Subject: Oconee Nuclear Station
Docket Numbers 50-269, 270, and 287
Supplement 2 to License Amendment Request
associated with the Passive Low Pressure
Injection Cross Connect Modification
Technical Specification Change (TSC) Number
2003-02

Attachment
RAI-12 Response Related to Oconee Amendment Request

Figure 1. Comparison of Leakage Size Cracks for Various Crack Morphology Parameters

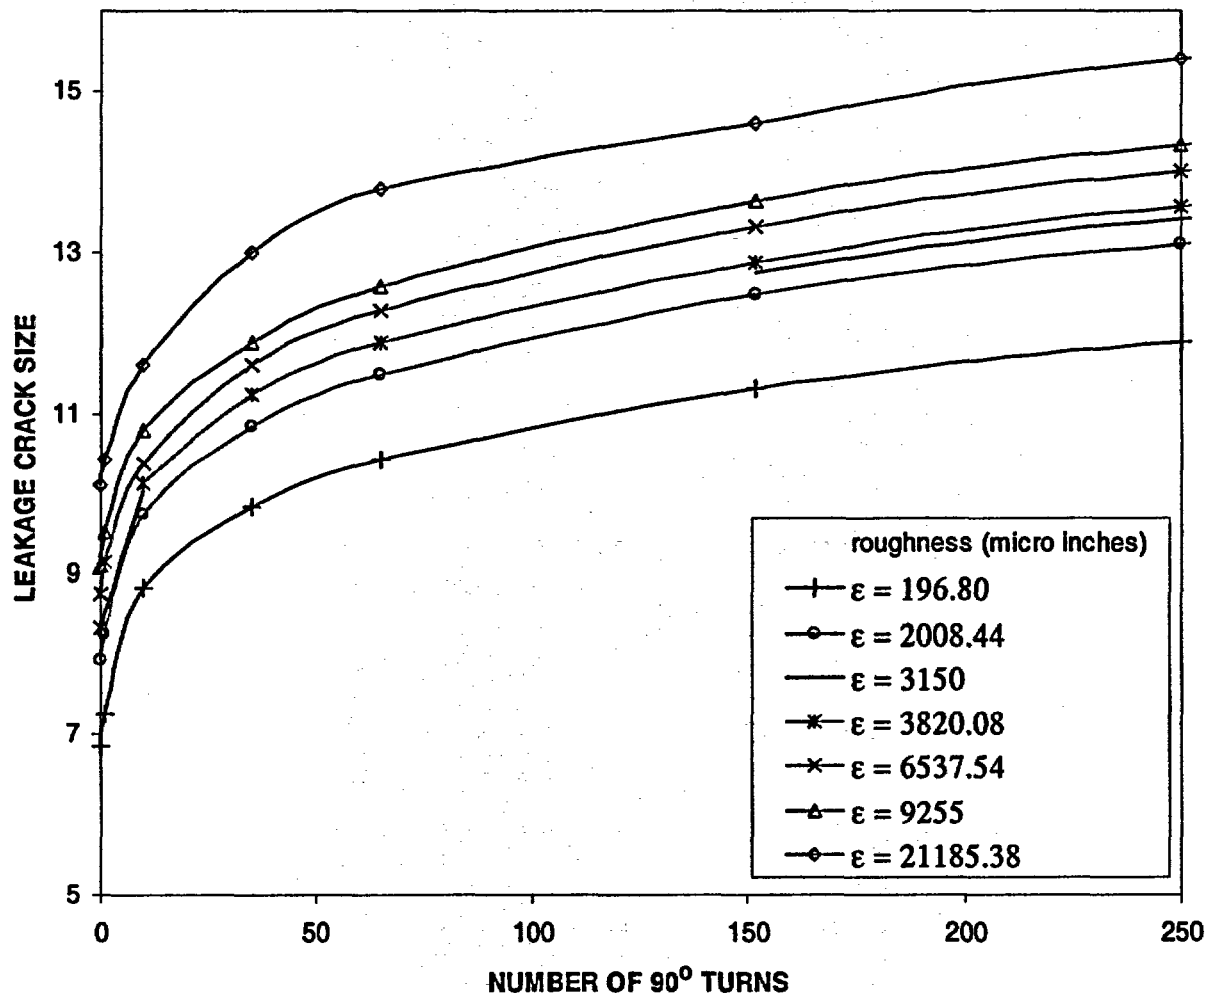
RAI-12: Due to the recent V.C. Summer event of primary water stress corrosion cracking (PWSCC), the staff has a general concern over PWSCC and other unidentified degradation mechanisms on proposed LBB piping. As a result, the staff requested recent LBB applicants to perform a sensitivity study using a crack morphology (surface roughness and number of turns) characteristic of transgranular stress corrosion crack (TGSCC). Information contained in NRC NUREG/CR-6443, "Deterministic and Probabilistic Evaluations for Uncertainty in Pipe Fracture Parameters in Leak-Before-Break and In-Service Flaw Evaluations," may be useful. You only need to perform this analysis for SMAW weld at location 2 having a margin of 2.4 on flaw sizes. The staff understands that using the suggested TGSCC crack morphology will reduce the margin significantly. The purpose is to know how much margin (10 for leakage, and 2 for flaw sizes) that the piping still has should a TGSCC occur.

57 tests (utilizing FANP's program KRAKFLOW) were run using combinations of the surface roughness and number of turn values in Table 1. It was decided to maintain the margin of 10 on leakage. The resulting leakage size crack lengths and margin on flaw size were determined for the various permutations of crack morphology. Table 2 lists the leakage size cracks and Table 3 lists the corresponding margins on flaw size. Figures 1 shows the leakage size crack lengths vs. number of 90° turns, while Figure 2 shows the margin on flaw size vs. number of 90° turns.
